PLANNING AND DEVELOPMENT SERVICES STAFF REPORT

For Planning Commission Meeting of May 21, 2013

**SUBJECT: 414 Main Rezoning and Site Plan
Project Nos. Z13-004 and SP13-008**

**401 N. Fourth Avenue Rezoning and Site Plan
Project Nos. Z13-005 and SP13-009**

401-403 N. Fourth Ave.
Ann Arbor, Michigan
Fourth Avenue Building - Elevations

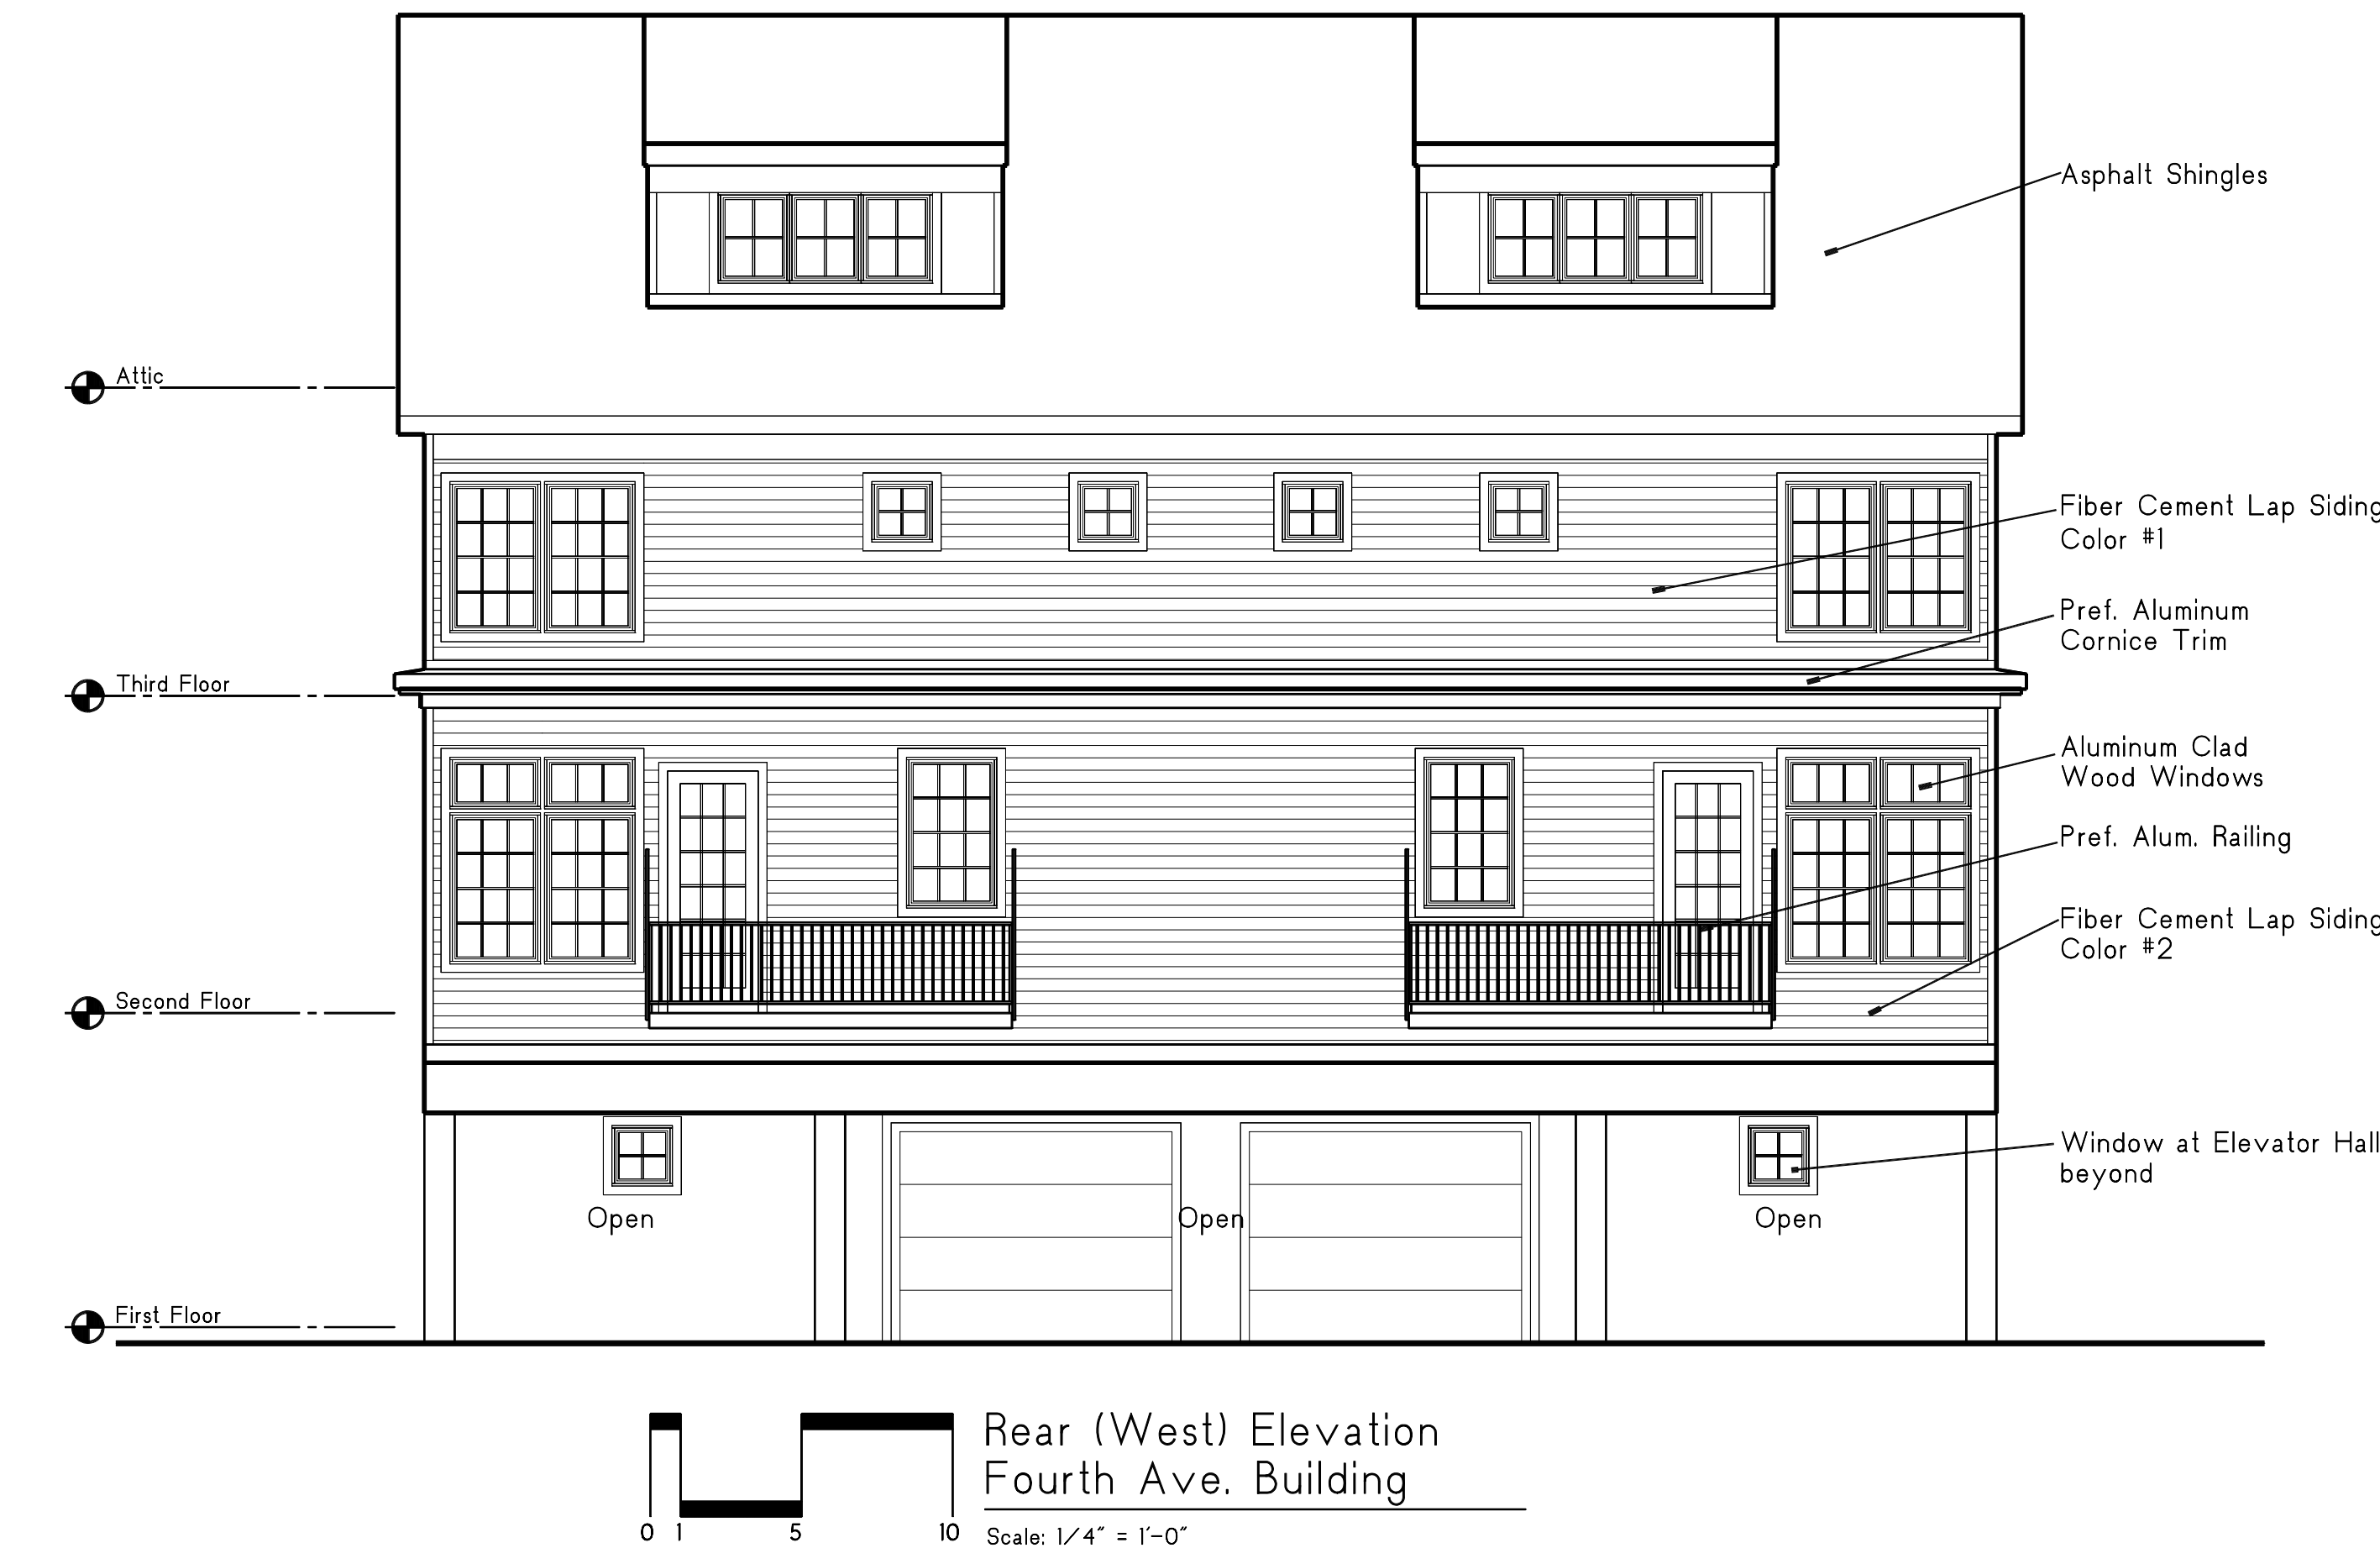
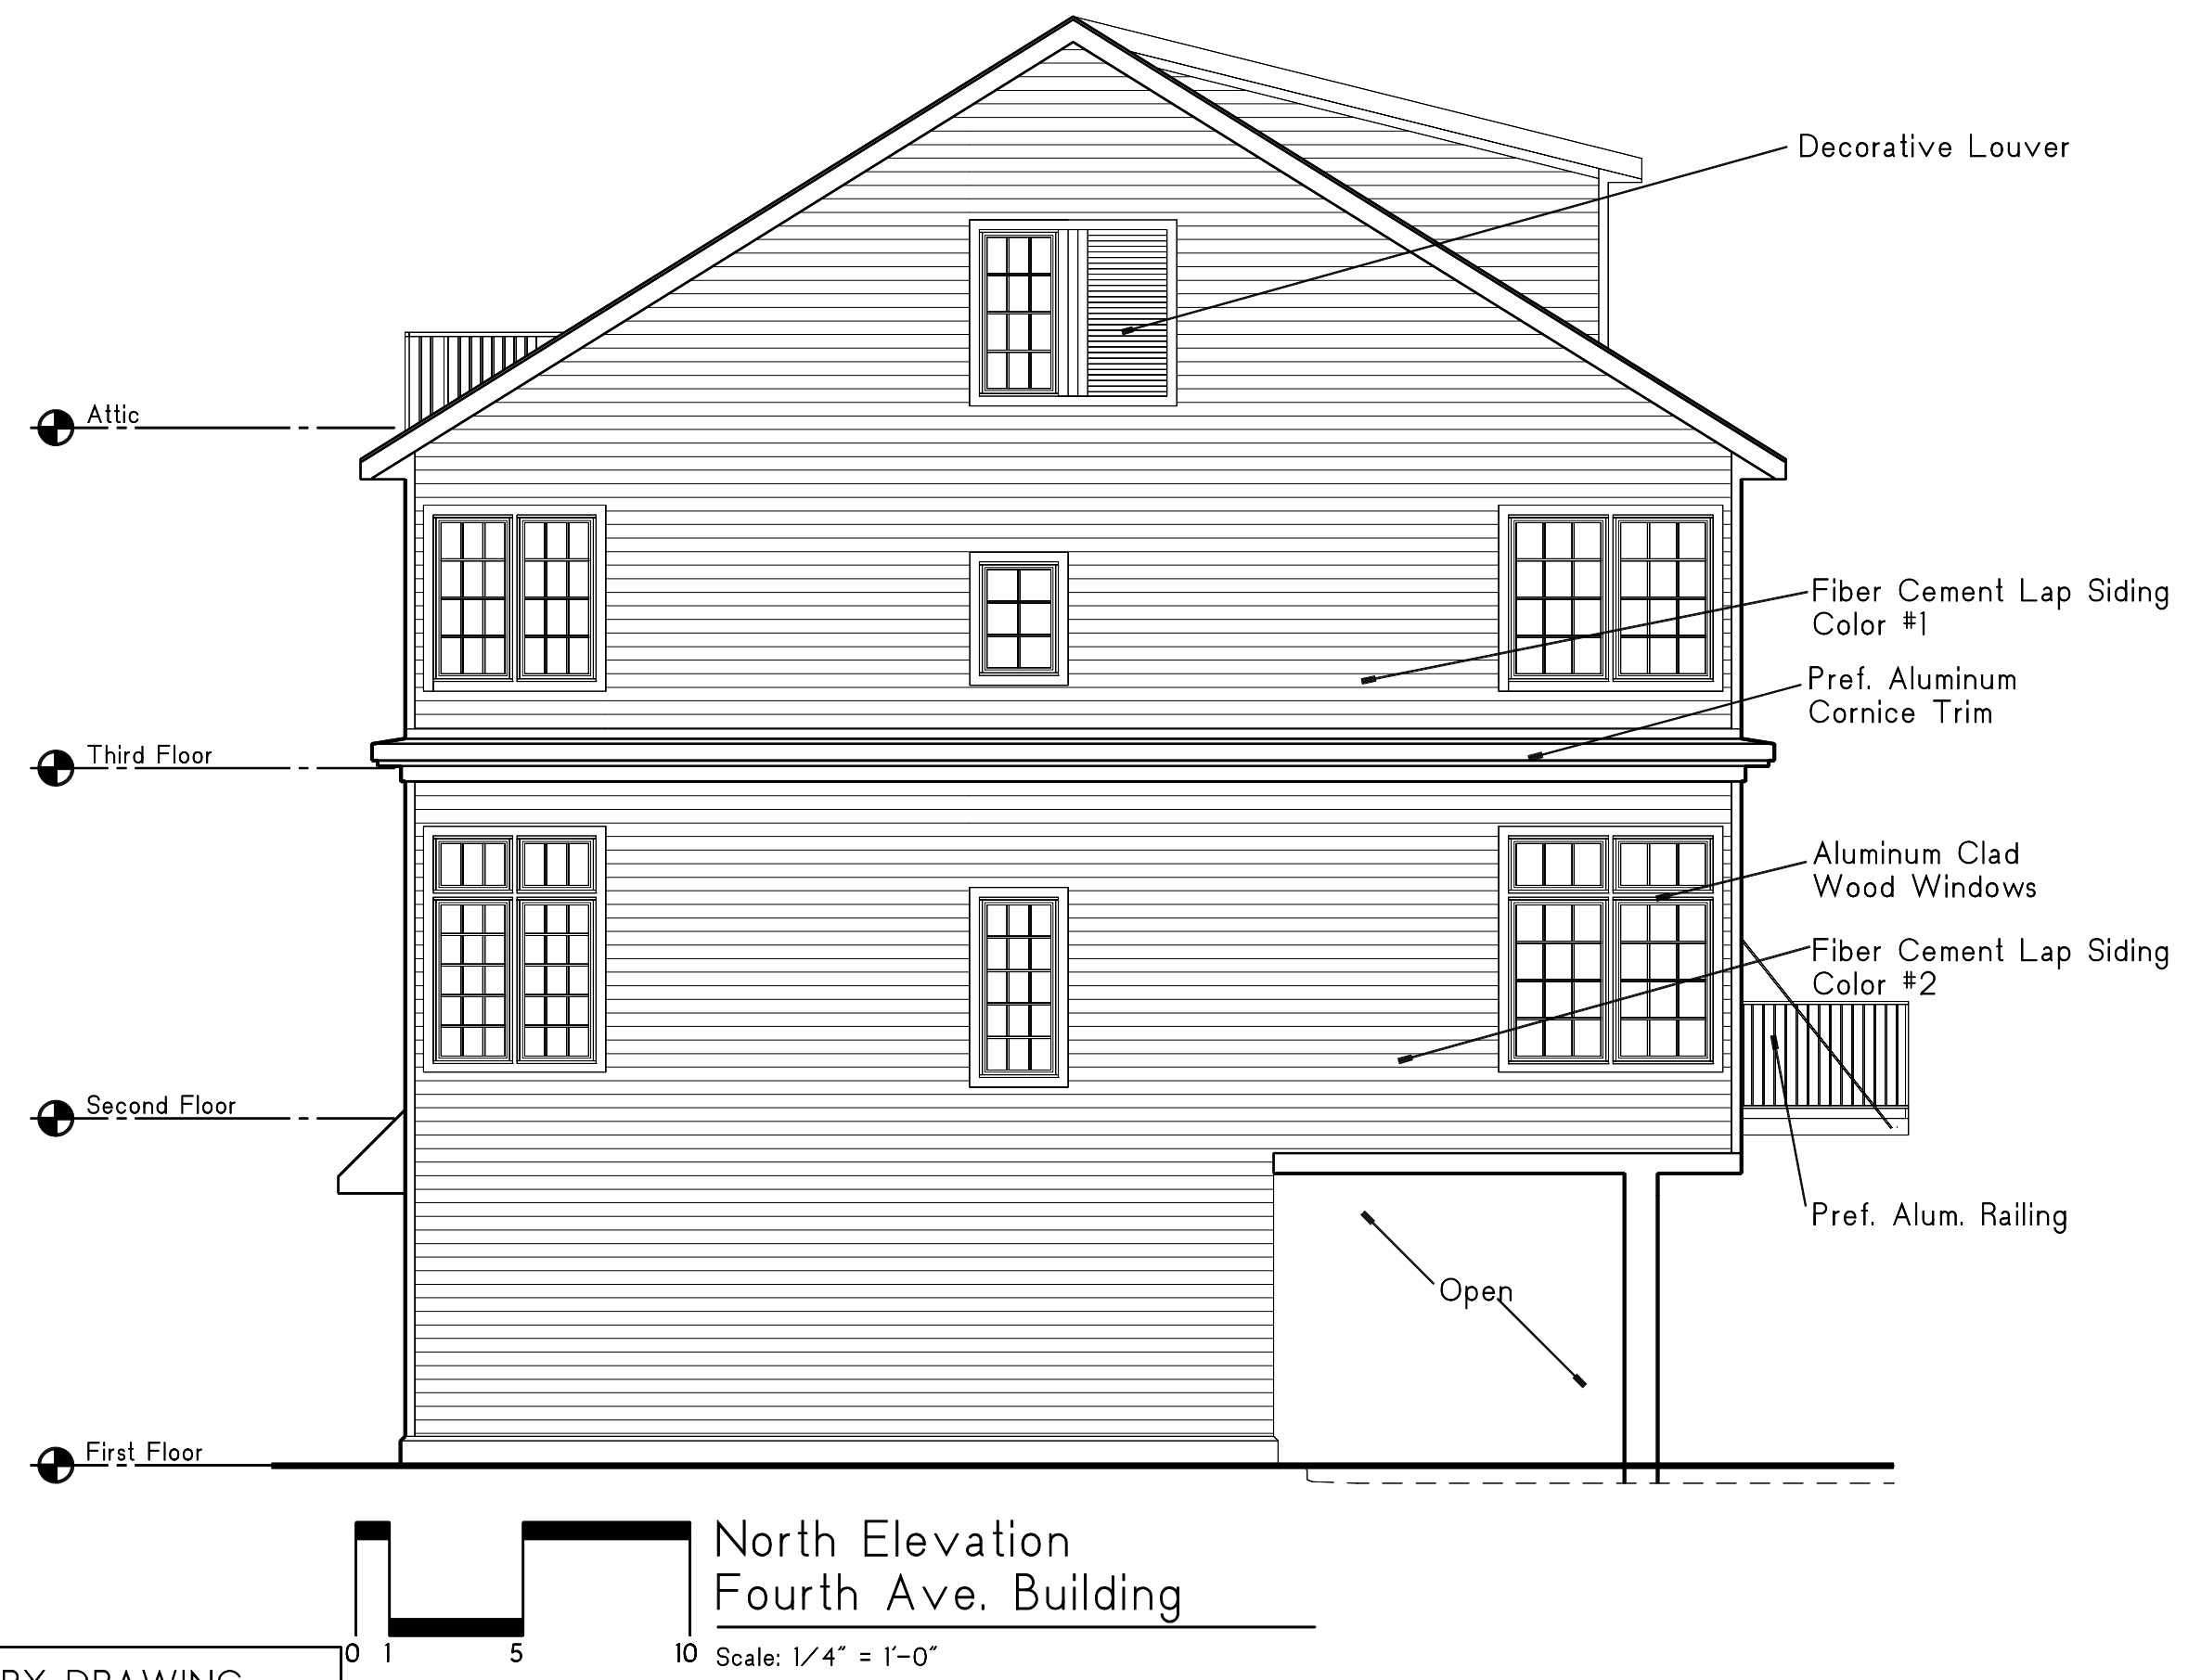
Second, regarding the Fourth Ave building, the two double-wide garage doors dominate the street level façade. The Fourth Ave garage doors were cited as the one glaring deviation from the intent of the design guidelines and the Board felt the doors were no better than a surface parking lot. The garage doors overwhelm the existence of the pedestrian front doors to each unit. The design team explained there was not enough lot width to accommodate a double-loaded parking lot and two double-garage doors at the rear of the building. The design team also noted that if the garage doors were relocated to the rear of the building, the Fourth Avenue street level façade would still not have active uses. The Board felt that a blank wall with landscaping between the building and sidewalk would be an improvement and better achieve the intent of the design guidelines.

Two double garage doors on the east side of the building have been replaced with two single garage doors on the east side and two single garage doors on the west side as recommended by the DRB. Additional landscaping has been added to the east side of the building.
